Knife River Corporation – Northwest

Delivered by email: Vaughn.Balzer@dogami.oregon.gov
Re. Response to Comments, DOGAMI, DEQ, EPA and Revised Sampling Plan

Woodward Site (DOGAMI ID #07-0159)**Groundwater Investigation Plan****Short Form: Responses to DOGAMI Comments dated March 5, 2025**

Sampling Plan Vanier Expansion Woodward Mine

Figure 5 Shallow Aquifer Water Table Map

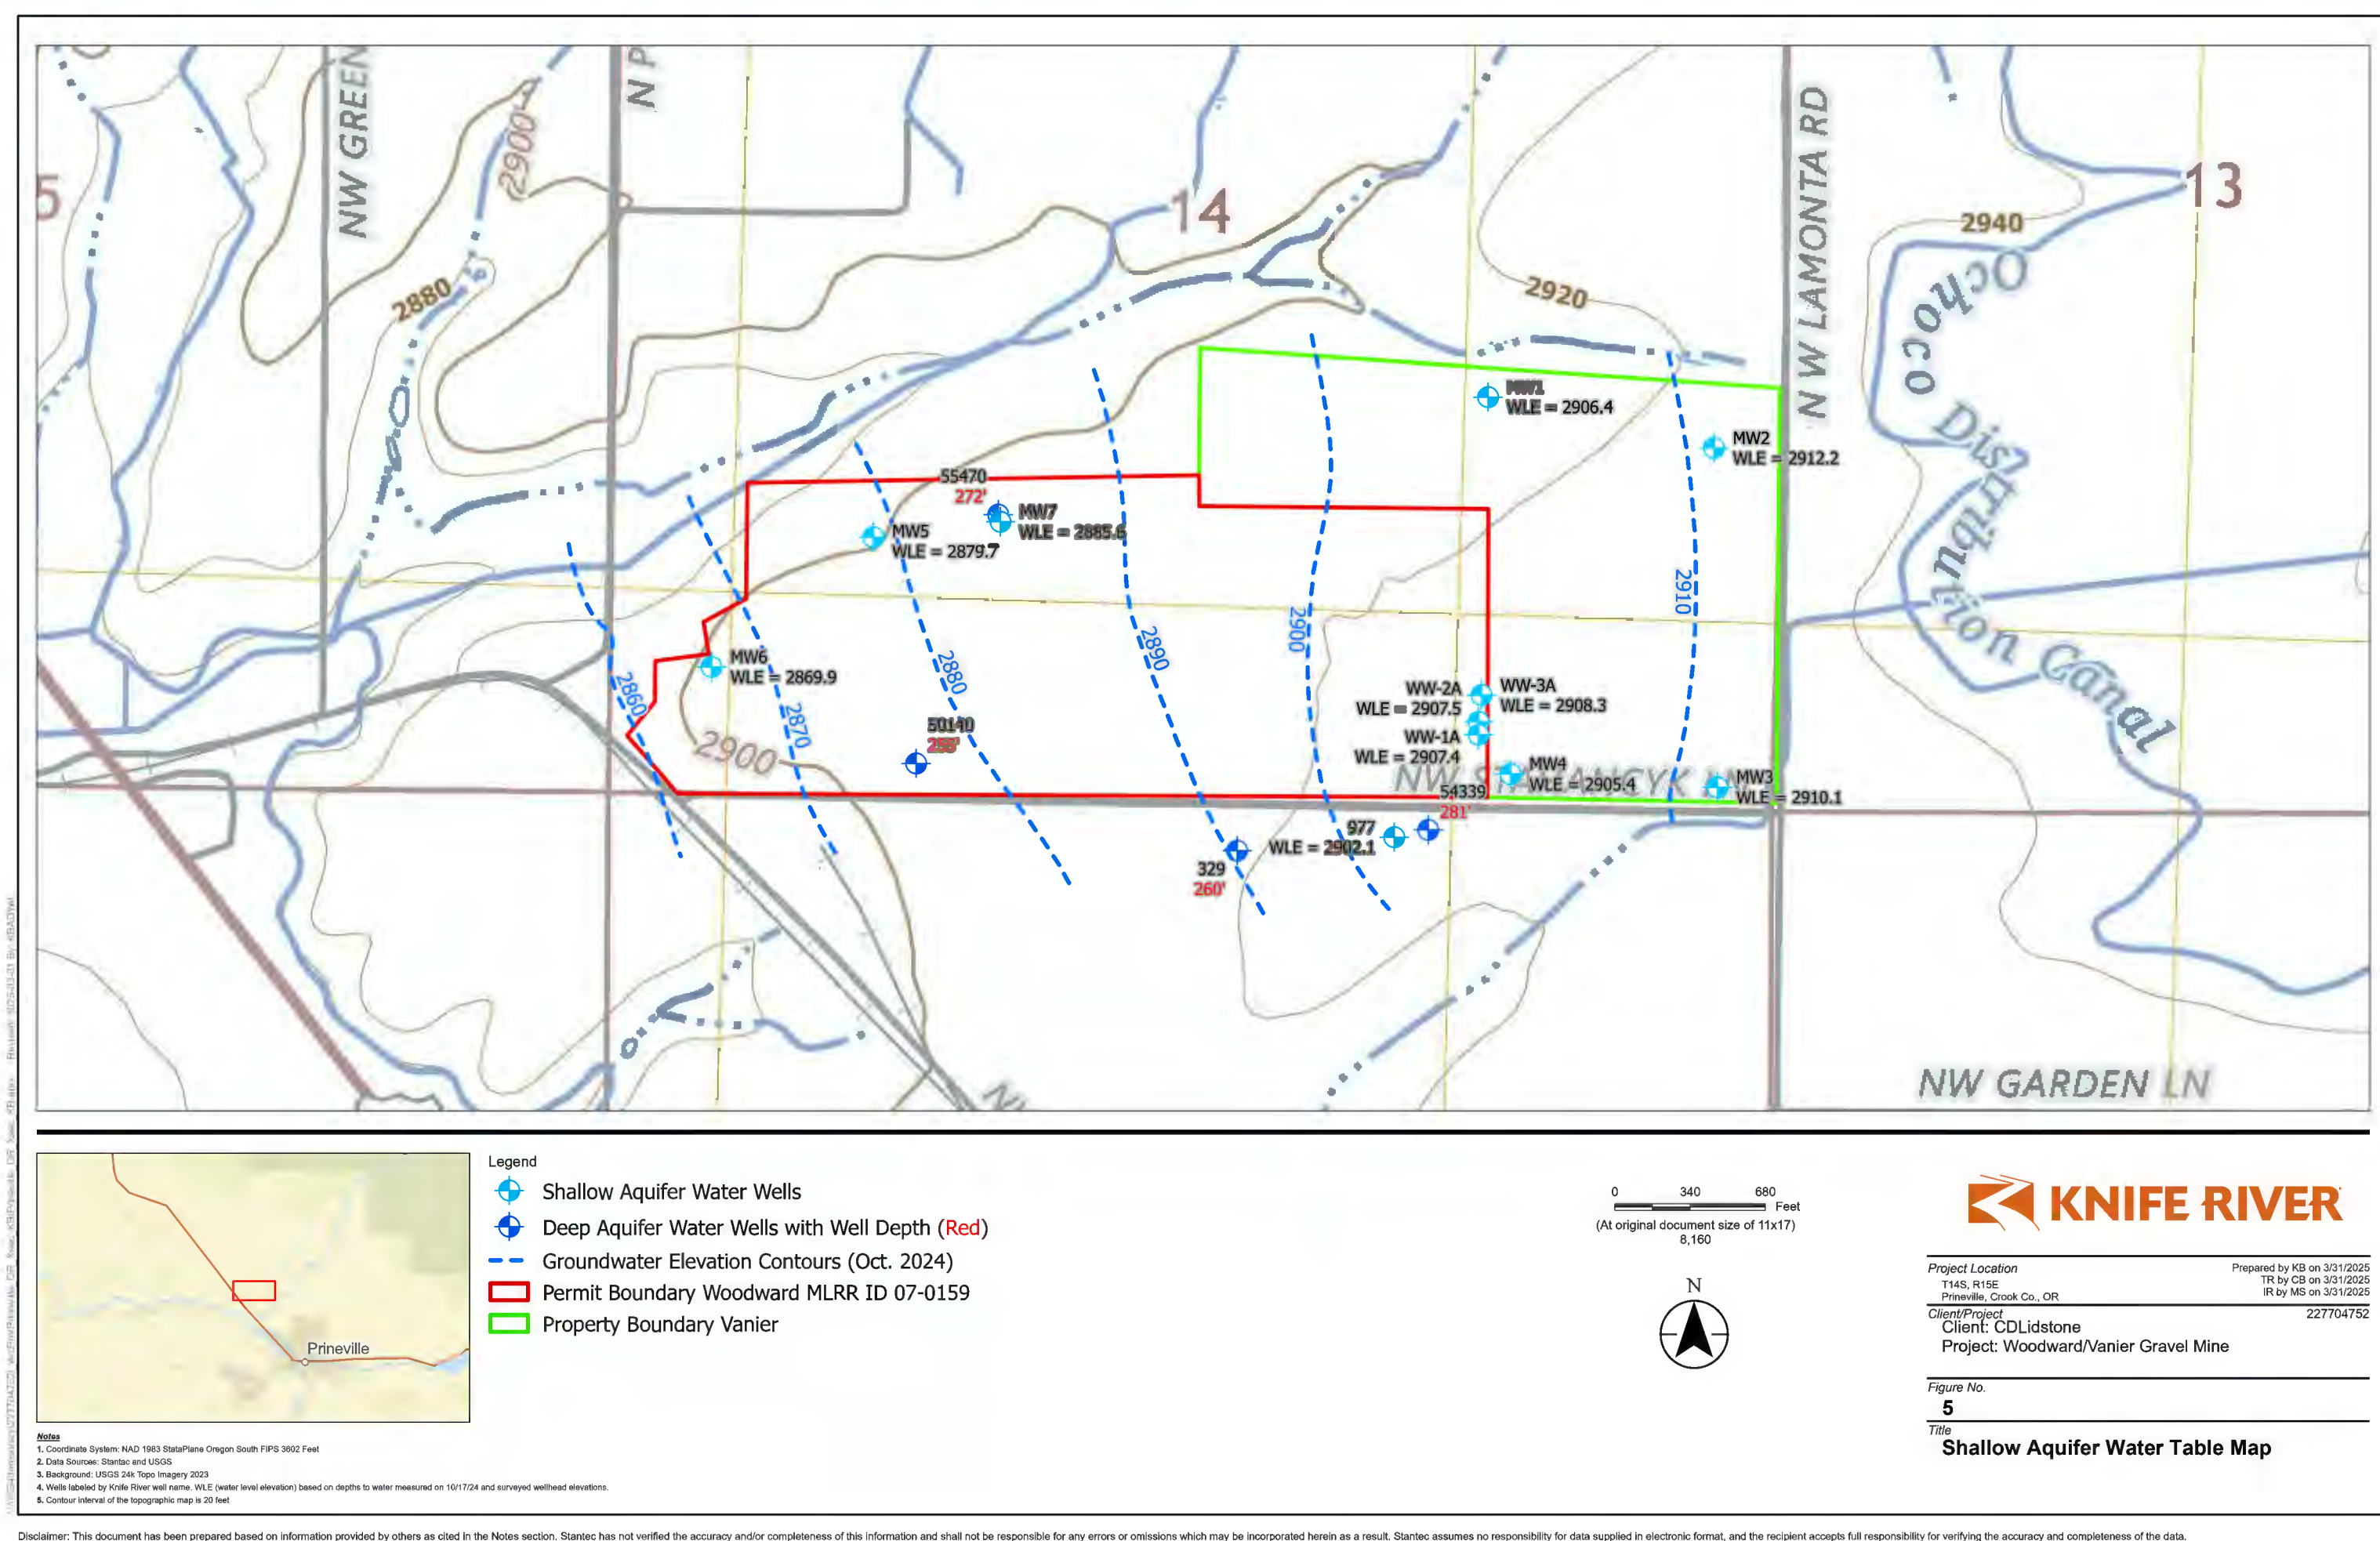
45. **PDF Page 18, Figure 5 (DEQ):** Groundwater gradient. The groundwater gradient appears fairly flat in the Vanier section of the property so it is difficult to tell if the offsite wells are truly cross gradient or somewhat downgradient. Contours should not be extended past the ditch/slough unless there is data supporting that. The series of wells WW-3A, 2A, 1A and MW 4 and 3992 indicate a southern groundwater flow direction in that vicinity which may be influenced by the creek.

46. **PDF Page 18, Figure 5 (EPA):** Remove 2860-foot contour and dash contours that are inferred.

47. **PDF Page 18, Figure 5 (EPA):** Well ID for 3992 does not correspond to well IDs on Table 1. Please provide consistent names/well IDs on both figures and tables. 3992 is an address, but the well ID should be included in the name to avoid confusion.

Response: *The water level contours have been modified such that they do not extend past the ditch/slough.*

Response: *The 2860-foot contour has been left on the map, and all water level contours have been dashed. This is our best picture of what groundwater flow conditions look like for now.*

Response: *Because there are two wells at Mikulski and these wells have been sampled for a number of years, sample names have been changed. The shallow and active well is identified as 3992. The deep well is identified as 3992-Deep. This is identified on **Figure 1** and **Table 1** and **Table 3**.*
